Re: *Sunset Lofts, Traffic Engineering Comments (12/16/21)*

PZ21-00018 (DEV)
Sunset Lofts (comprehensive)
12/16/21

Engineering Comments

SEDONA LOFTS

Table 1. LOS Summary Comparison, Potential Lane Configuration Change at SR 89 and Sunset/Coffee Pot

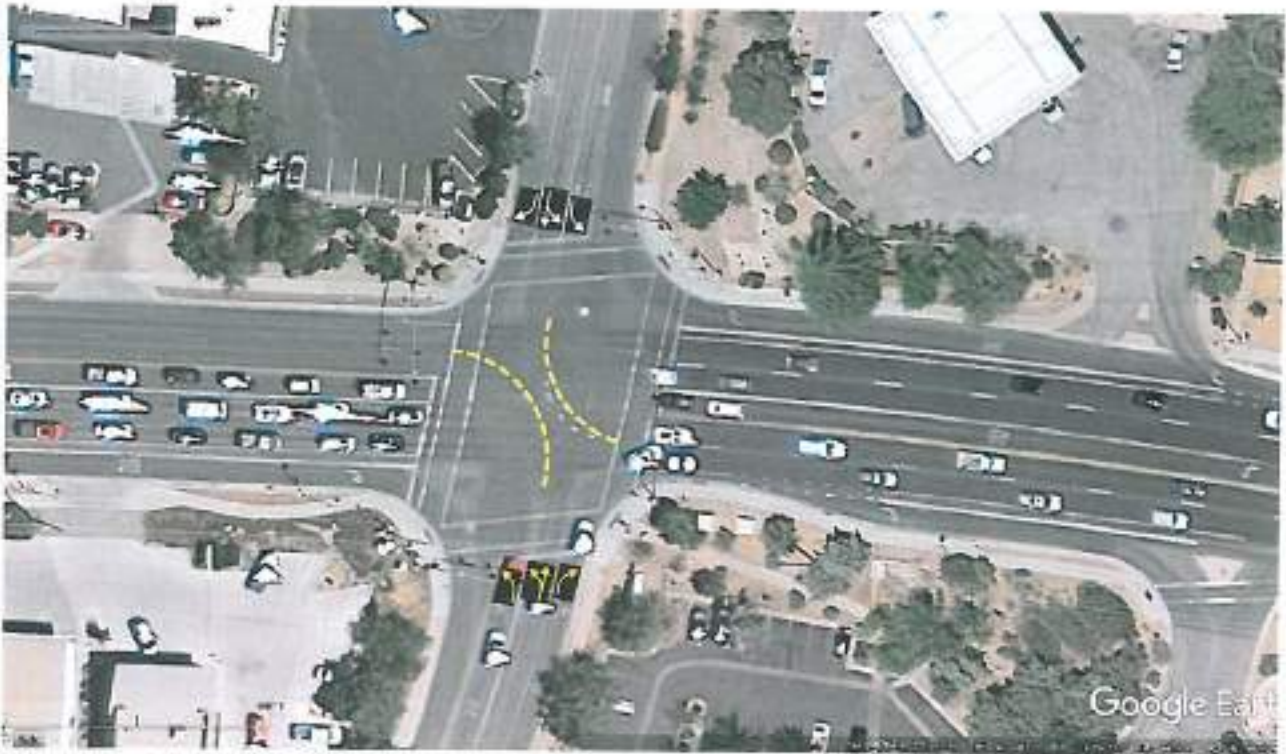
The report suggested a potential improvement to the SR 89A/Sunset Drive/Coffee Pot Drive intersection to modify the northbound middle lane from a through lane to a shared through/left lane configuration, but did not indicate the LOS impacts associated with this modification. Table 1 shows the requested LOS summary comparison of the two conditions, the top half under existing intersection conditions and the bottom half with the modified northbound approach. In review of the results, similar delays are anticipated for the northbound movements, but with the left turn and through movement queue combined and equally distributed across the two lanes, reducing the back of queue length from approximately 195 feet to 155 feet. Because the northbound phase is expected to "gap out" sooner, additional green time to the higher volume east/west approaches can be provided, slightly improving conditions for these movements and the overall operation of the intersection. The Synchro output sheets for the modified intersection design is attached while the existing condition output sheets are included as part of the original report.

If the northbound approach lane configuration is to be changed, the N/S pavement markings for the left-turn movements will also require modification, as shown in the attached graphic. Potentially, the east and west crosswalk and stop lines may need to be shifted outward.

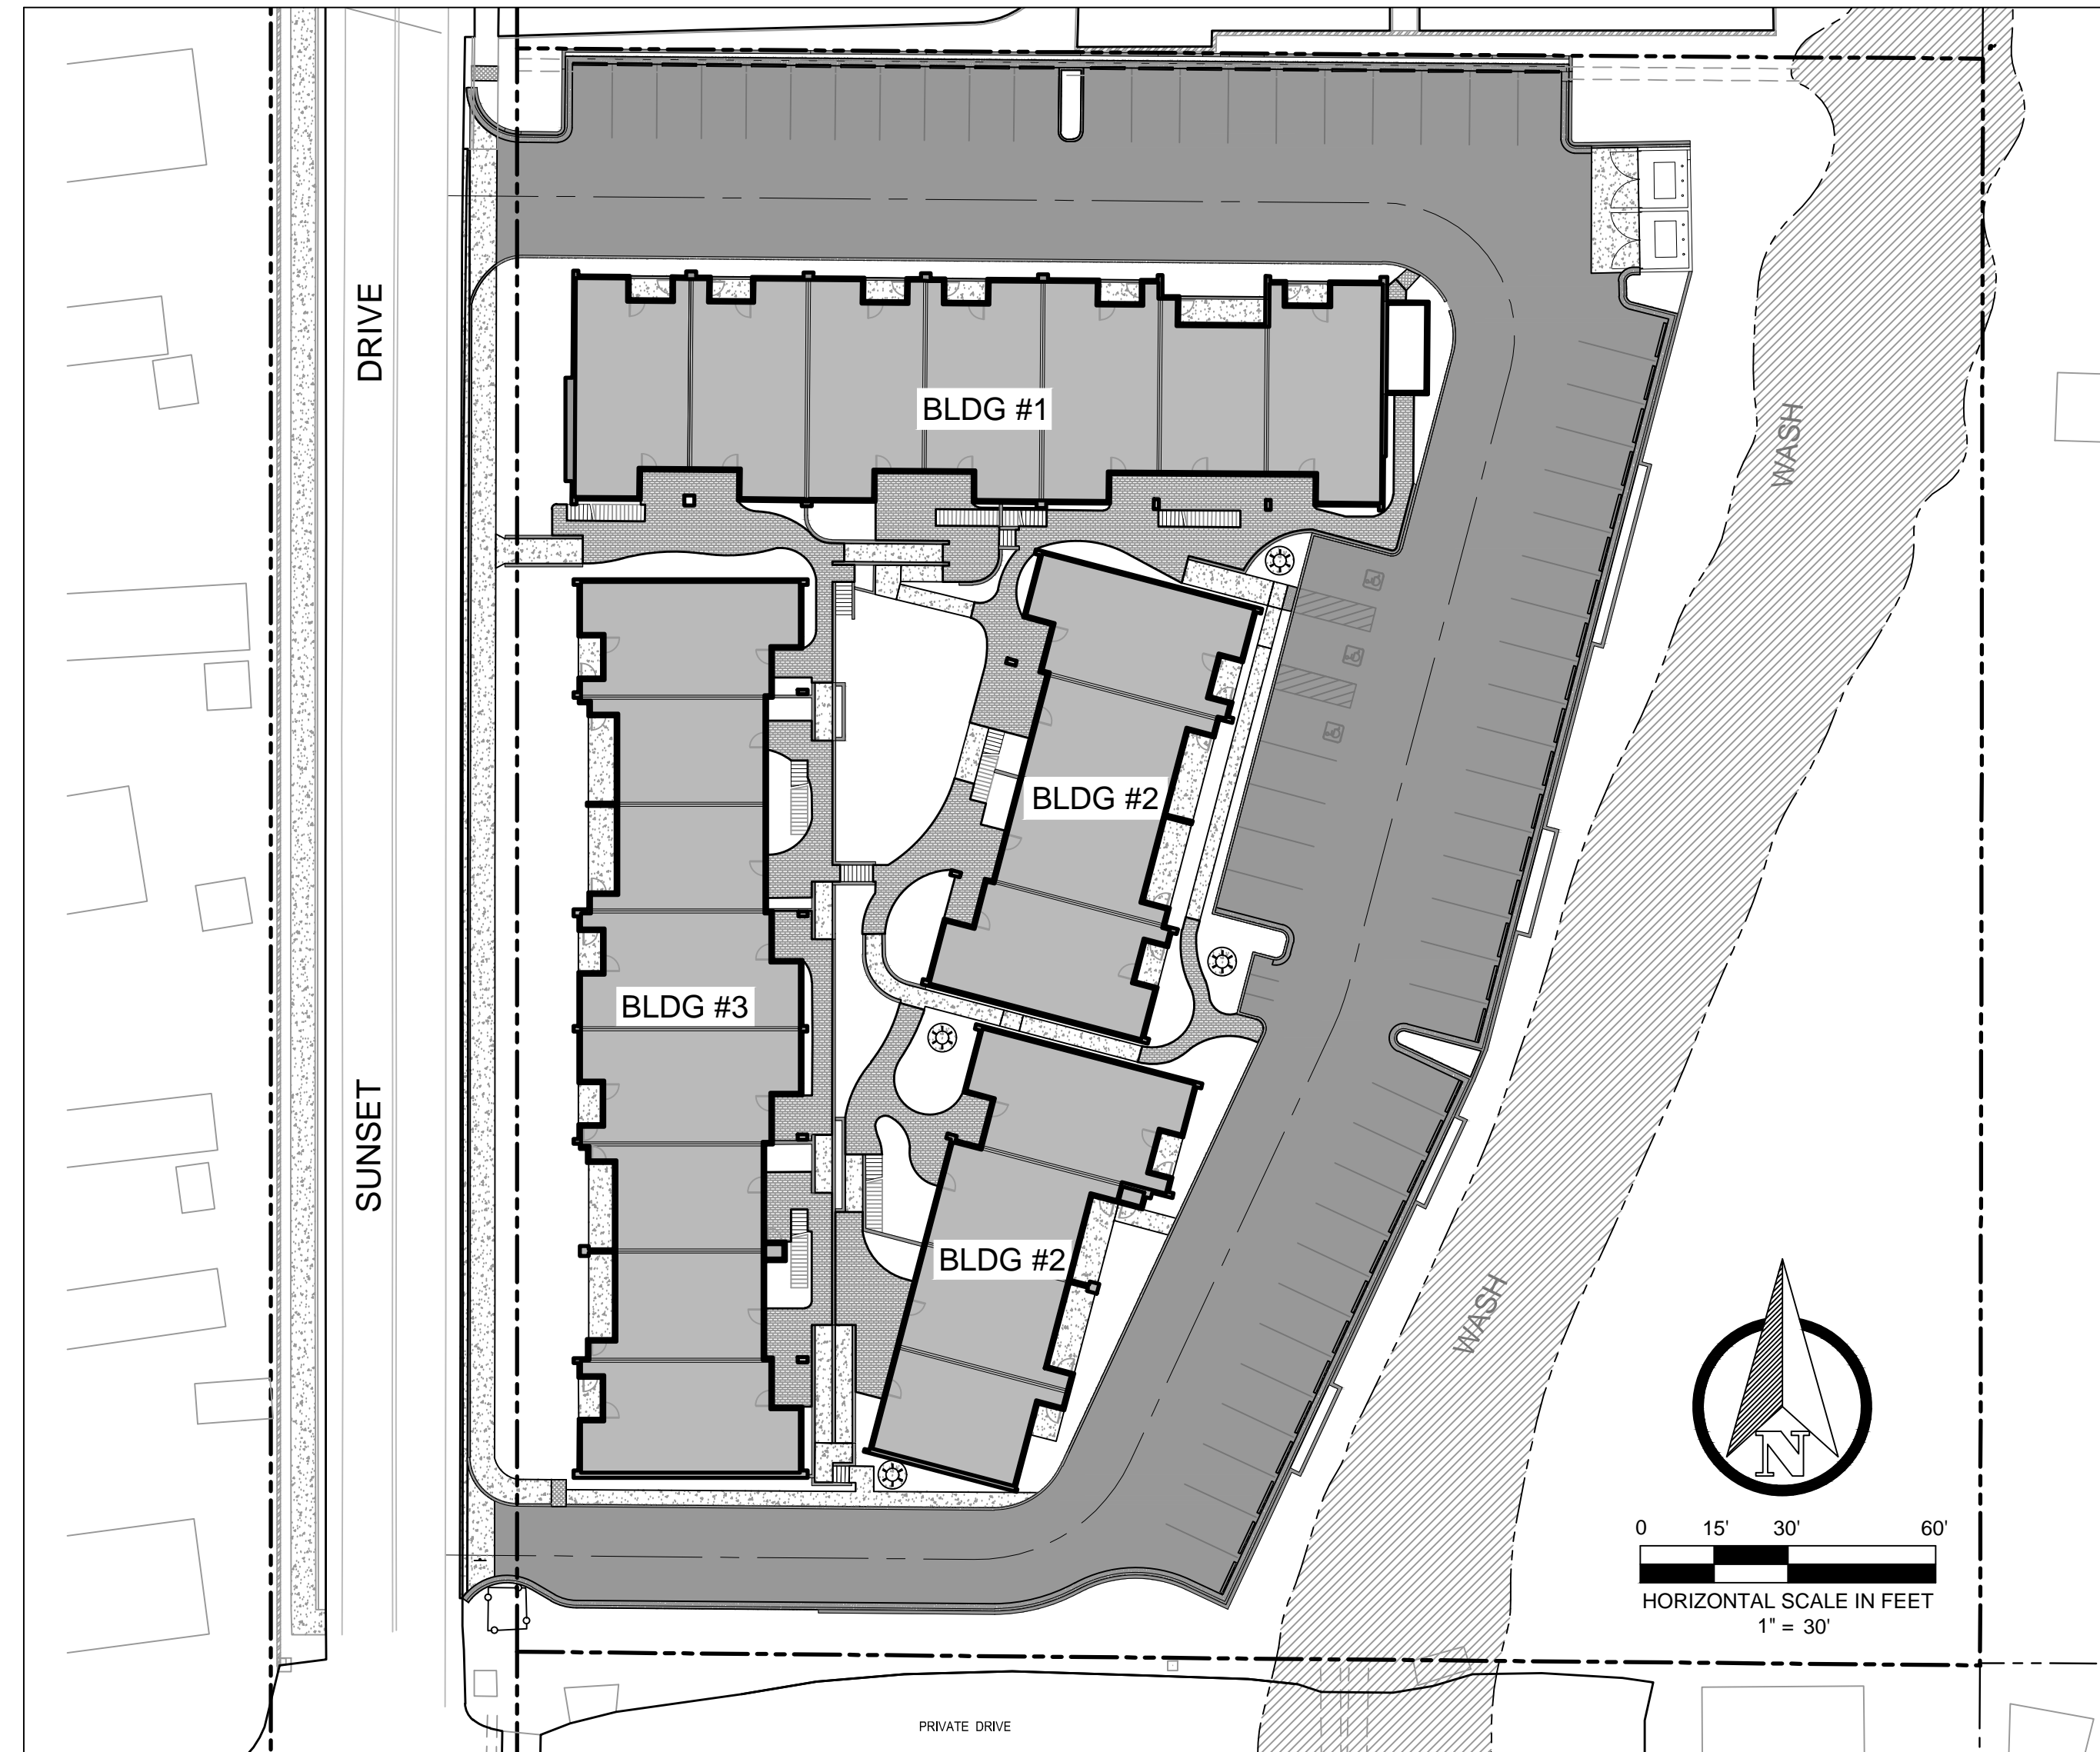
1. In the traffic impact analysis, show the effect on LOS at 89A if, as suggested, a 2nd left turn/through lane was added.
2. Stormwater storage cannot be placed in the floodway.

3. Please provide a geotechnical report. Percolation test results may help with subsurface retention & infiltration. A detention chamber method is preferred over voids in gravel. Retention below the parking lot is also an option.

4. Demonstrate the flow patterns if the confined central retention pond overflows from the exit pipe clogging.
5. Minimum stormdrain size is 18" per DREAM Table 3.1 for maintenance purposes. Provide storm drain cleanouts every 300ft and MAG505 collars at bends.

6. Please provide a drainage report reflecting changes to the stormwater detention.
7. Elaborate on the 2' gravel apron. Consider landscaping/seeding/grasscrete/biofilter. Is an additional curb needed to delineate the edge of asphalt during paving?

8. Adjacent grades should slope away from buildings. A swale is recommended on the western side of Buildings 3 & 1 to direct water away from the structures, or propose retaining walls & space between the habitable space and drainage.

9. Please provide a sewer design report.
10. Provide letters of serviceability for all utilities.
11. Relocation/alteration to the utilities in the right-of-way may be required to maintain visibility at the southern driveway.

12. Show ADA units. Provide 5' internal sidewalks.
